ADDENDUM NUMBER ONE – MAY 19, 2016

<b>Company:</b> RE Werner Architects	<b>Sets:</b>
<b>Address:</b> 1354 Lawrence County RD 2225 Verona, MO 65769	<b>Date:</b> 5-17-16
<b>Re:</b> Window Technology, Inc. Addendum 1	<b>CC:</b>

Re: Wintech Window Technology  
201 Industrial Drive  
Monett, Missouri 65708  
Project #4183

ONE LINE ELECTRICAL  
FOR 72 x 144 SB FURNACE

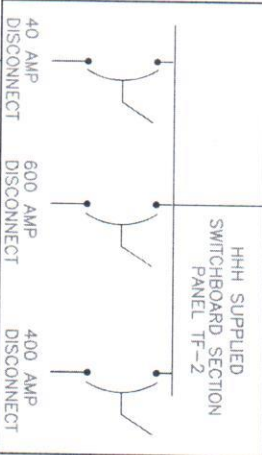
1. "PC" shown at the switching locations for the lights on the inside of the building shall be motion sensors equal to Lithonia Lighting WSXWH motion sensor with switch override.
2. The two charger outlets shall be 30 amp three pole twist and lock wall connections fed from 30 amp three pole breakers HV2-20,22,24 and 26,28,30. See sheet 3 (attached)
3. The riser has been diagram has been clarified for labeling, additional information on MDP-2 has been provided as well as some feeders have been clarified. Breakers for HV3 have been added to MDP-1
4. Additional information on the oven has been provided. It appears that the expectations from the oven manufacturer is that the electrical contractor will

provide two 800 amp disconnects as well as a 20 amp /120 volt shunt trip control circuit to this piece of equipment.

SHEET NO. 3 OF X

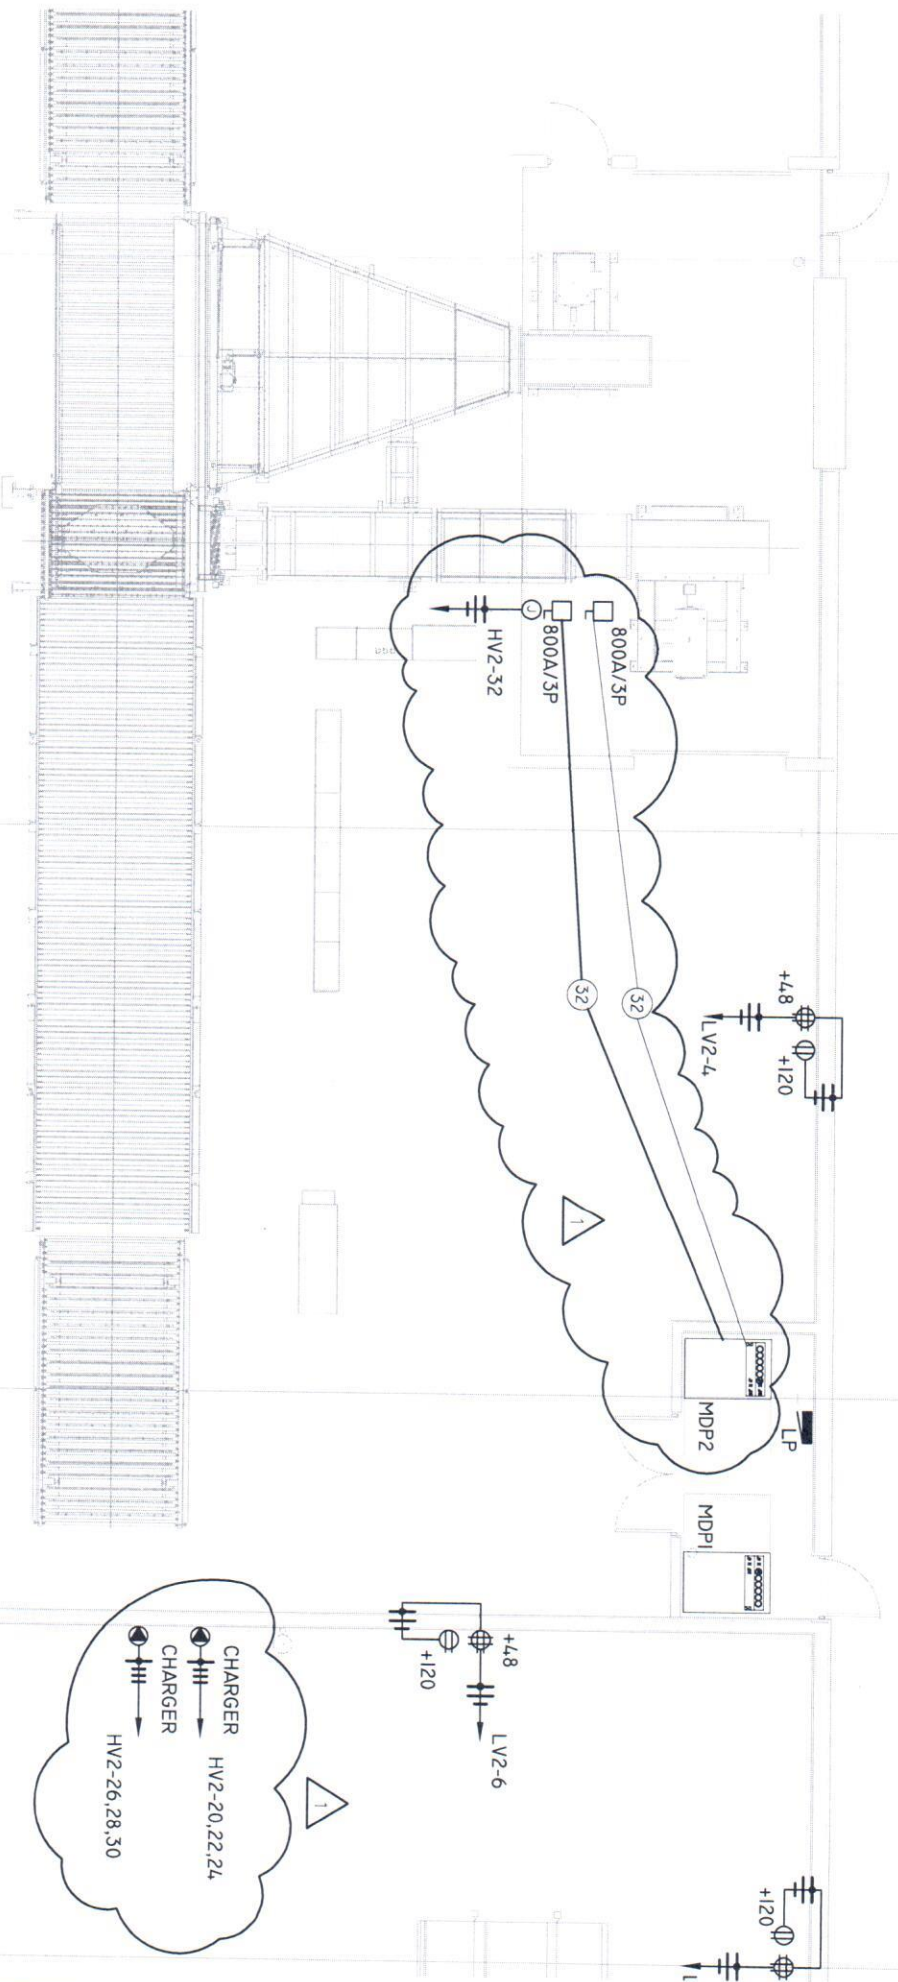
4.  
CONCRETE  
HOUSEKEEPING  
PAD BY  
ELECTRICAL  
CONTRACTOR.
